Project: Ben Steele Middle School
Addendum #: 4
Date Issued: January 22, 2016

Addendum Number:	04	Date Issued:	January 22, 2016
Project:	Ben Steele Middle School	Project Number:	13048.20
Pages in Addendum:	19 w/attachments	Prepared By:	Kris Koessl
Issued To:	All Planholders All Consultants Hulteng, Inc.

This Addendum's attachments consist of 1. Sanderson Stewart Addendum (4 pages), 2. Projector Spec Section 11 52 16 (3 pages), and 3. Revised sheets M0.2, M0.3, M0.4, M9.2, M9.3, and E7.1 (6 sheets)

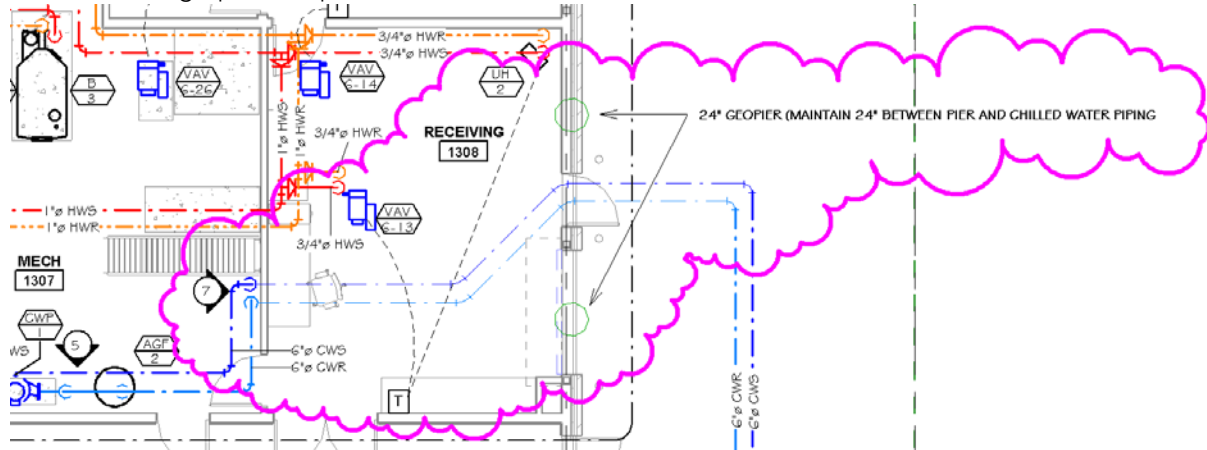
M0.1: Air Cooled Compressor Chiller Schedule, add the following:

2. The alternate chiller must meet the capacity listed on the drawings and must not have a MFS requirement over 700 amps.
 3. Review the site plan to see how any size changes would impact the design. Any significant enlargement should be carefully reviewed prior to bidding.

4. All other requirements of the drawings and specifications do not change including, but not limited to: capacity, size, noise levels, required accessories, etc.

5. This bid alternate will also include an electrical add for increased electrical requirements to feed the lower efficiency chiller. This is addressed in the electrical portion of this addendum.

6. This alternate is an owner option and will be evaluated by the owner after the bid.

7. The base bid shall remain as the specified chiller or approved equal.
8. See the modified bid form for further instructions.

16 MAKE UP AIR UNIT CONTROLS DETAIL

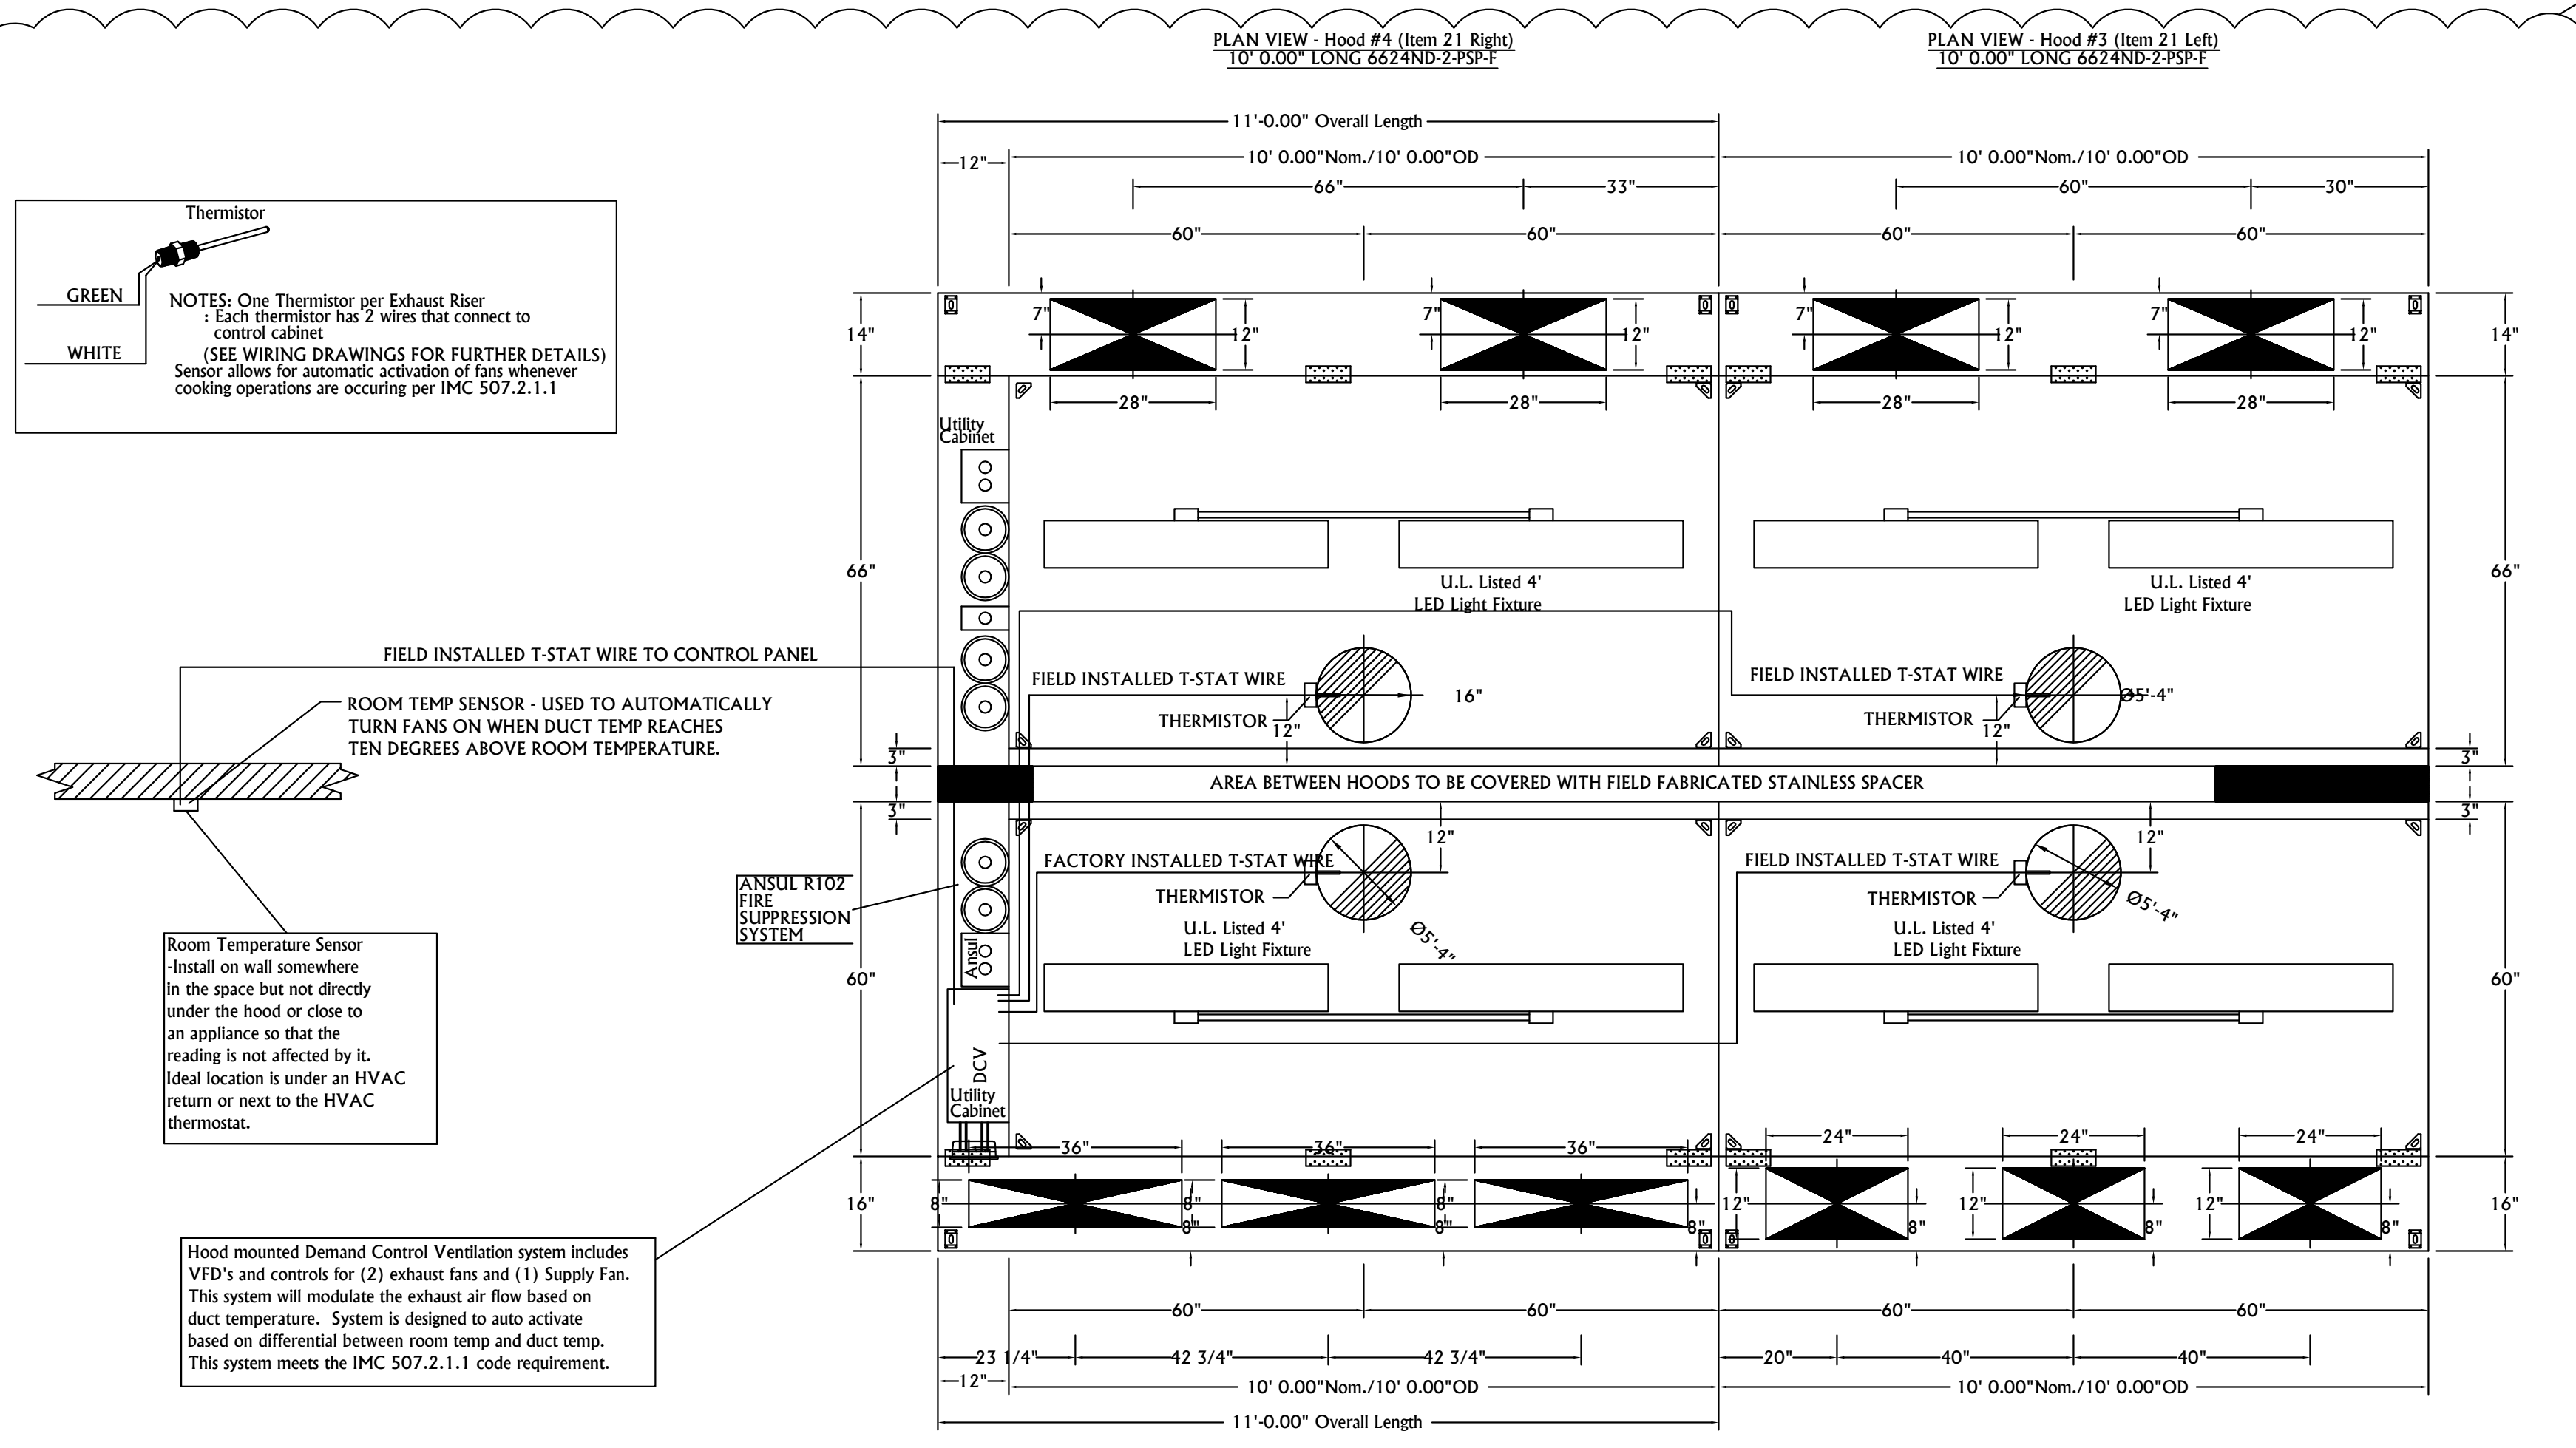
M0.2, M0.3, M0.4, M9.2, M9.3: replace sheets in their entirety with sheets attached to this addendum.

16 ELECTRICAL SITE PLAN
 E7.1 : E7.1 1" = 50'-0"

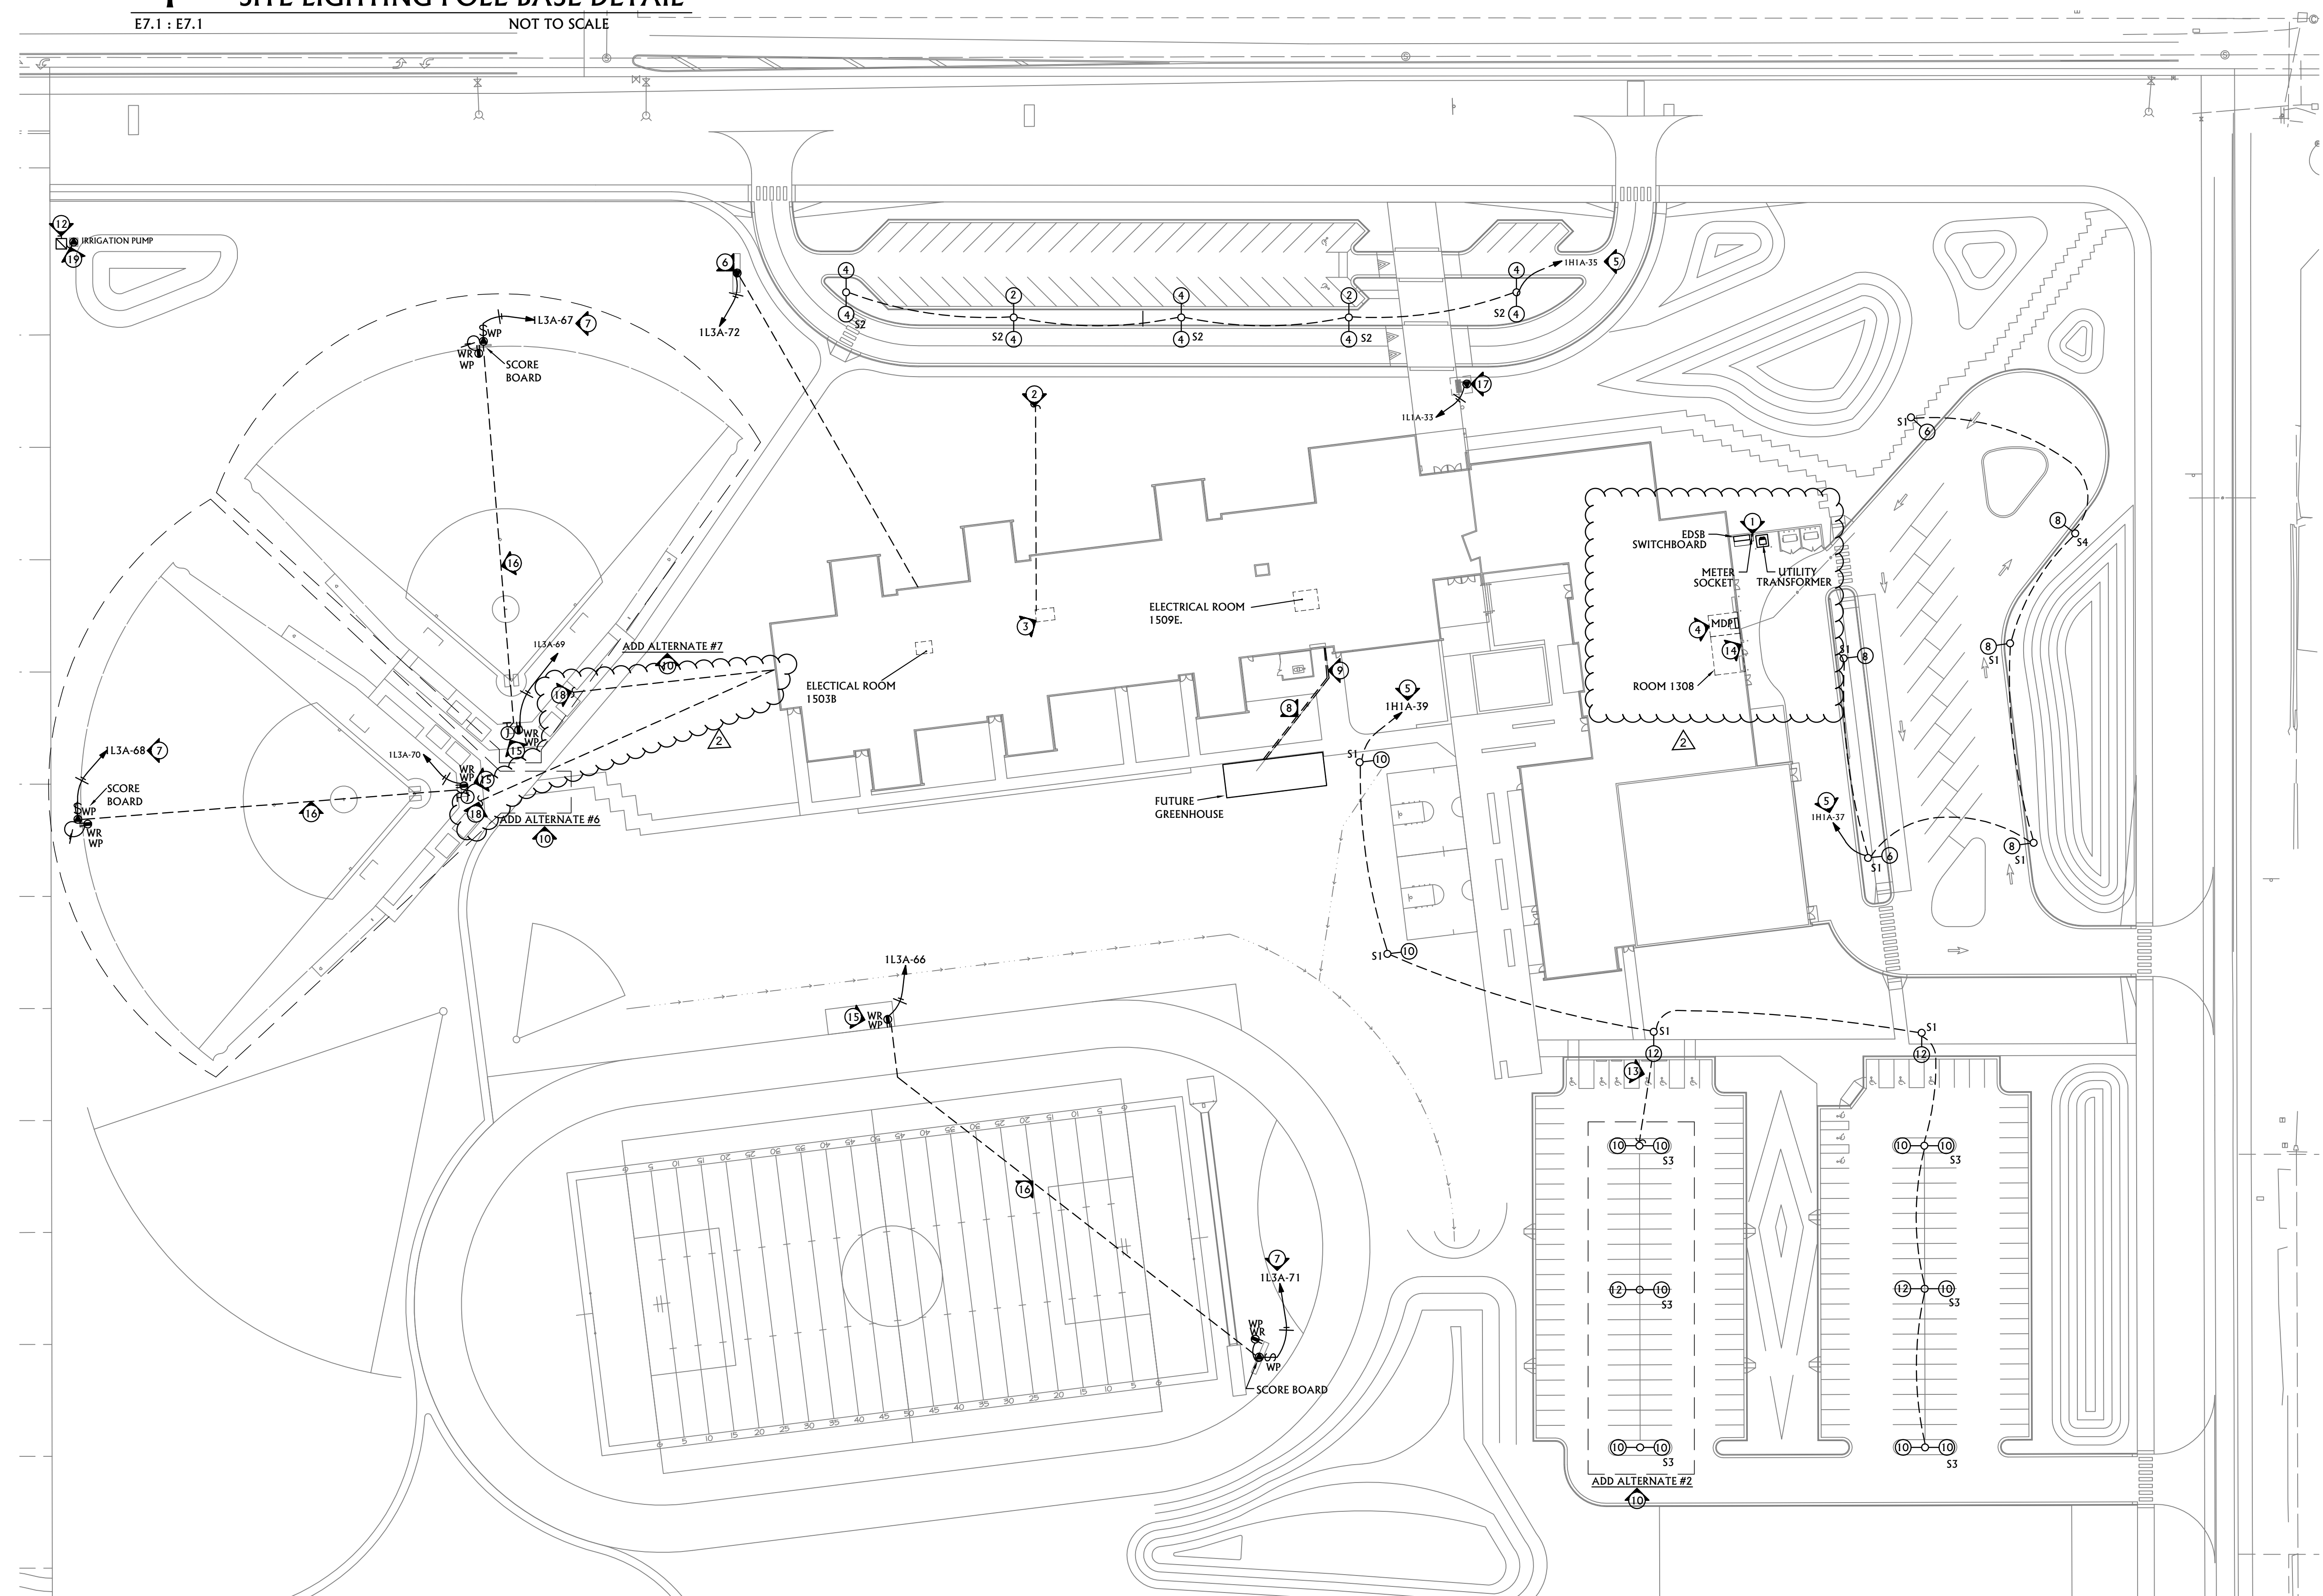
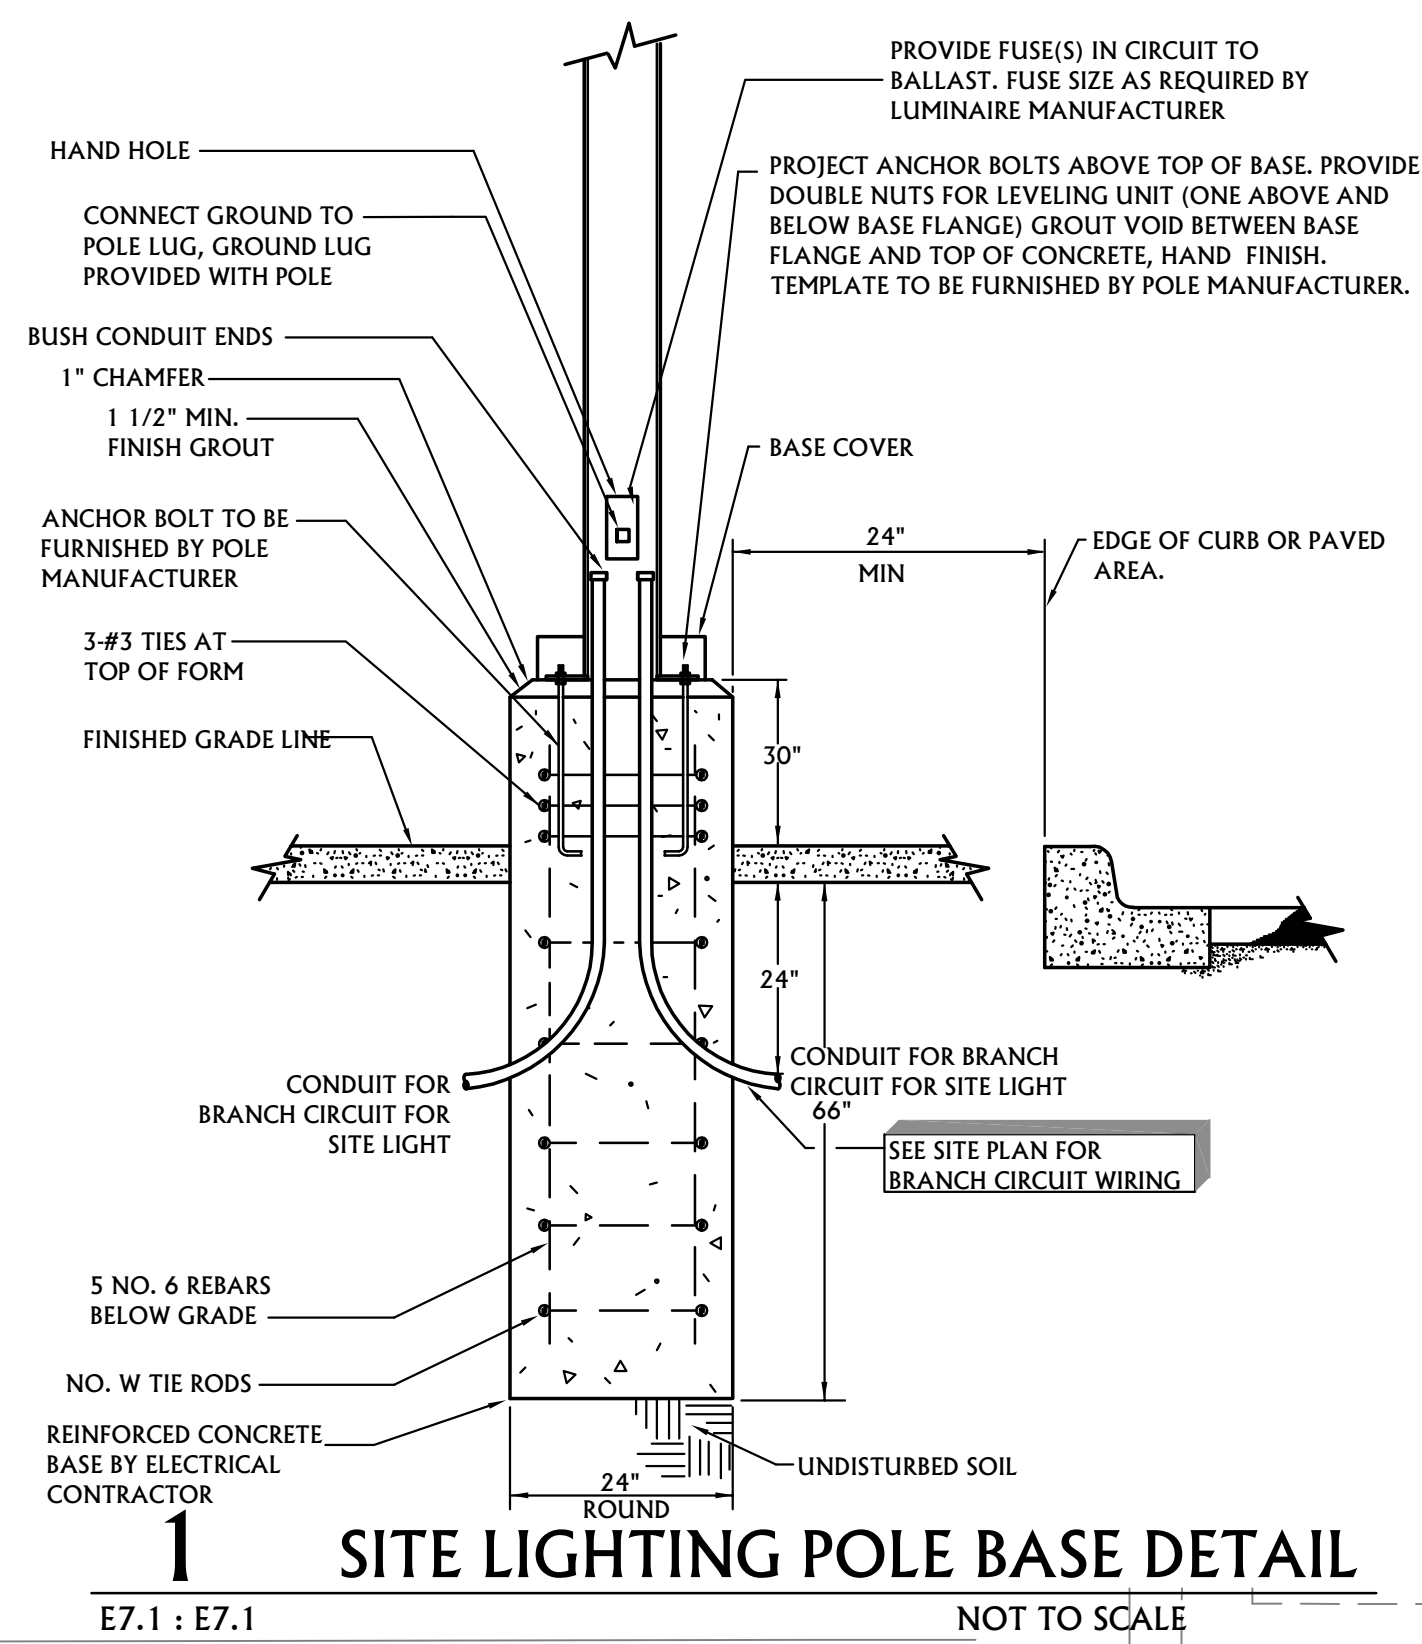
- **replace sheet in its entirety with sheet attached to this addendum.**
- change the verbiage of Key Electrical Note #18 to "As part of base bid the EC shall route (4) empty 1" c. w/ pull line's from panel "1L3A", located in room 1503B stubbing conduit out of the building to the dashed outline shown on plan for add alternate #6 and #7. Insure that all conduits are stopped past any hard surface (Sidewalk) and reside in landscaped area. Provide (2) conduits per alternate area. Cap and mark location for continuation if add alternates are accepted."

- AS PART OF BASE BID THE EC SHALL ROUTE (4) EMPTY 1" C. W/ PULL LINES FROM PANEL "1L3A", LOCATED IN ROOM 1503B STUBBED CONDUIT OUT OF THE BUILDING TO THE DASHED OUTLINE SHOWN ON PLAN FOR ADD ALTERNATE #6 AND #7. INSURE THAT ALL CONDUITS ARE STOPPED PAST ANY HARD SURFACE (SIDEWALK) AND RESIDE IN LANDSCAPED AREA. PROVIDE (2) CONDUITS PER ALTERNATE AREA. CAP AND MARK LOCATION FOR CONTINUATION IF ADD ALTERNATE'S ARE ACCEPTED.
